REVOLUTION HELICOPTER CORP., INC.

Revolution Helicopter Service Information Letter # 09191997

Affected Aircraft: All Mini-500 helicopters.

Subject: Optional Cyclic Bell Horn Modification.

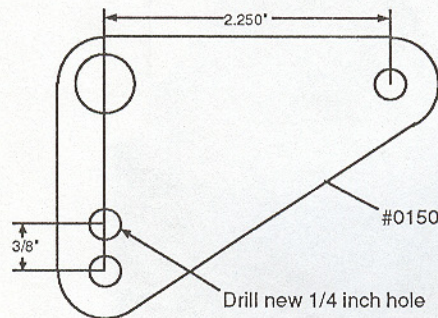
Through the ongoing factory testing and evaluation program carried out on the Mini-500 helicopter, RHCI will occasionally find ways to improve the Mini-500's flight characteristics. It has been discovered that with a small modification made to the cyclic bell horns (#0150), as seen in the Mini-500 Assembly Manual on Section 5, page 15 and 16, Fig. 30 and 31, will reduce the amount of fore-and-aft movements required, and allows for a more comfortable control range of movement.

The advantages found are: less throw necessary through translational lift, quick-stops, and less correction for entering autorotation. This modification is optional, and to the discretion of the builder/operator.

1. Disassemble and remove the cyclic bell horns (#0150) from the control system.
2. Place both #0150 together, and align with bolts or pins for accuracy.
3. Mark and drill a 1/4 inch hole through both parts, 3/8 inch away from center of previous 1/4 inch hole, as shown in drawing provided.

4. Reassemble both #015 to control system, and connect #BA12 assembly into new hole. Insure that all rod-ends are attached with ample threads, and jam-nuts are tight!
5. It may be necessary to adjust cyclic position to your comfort.
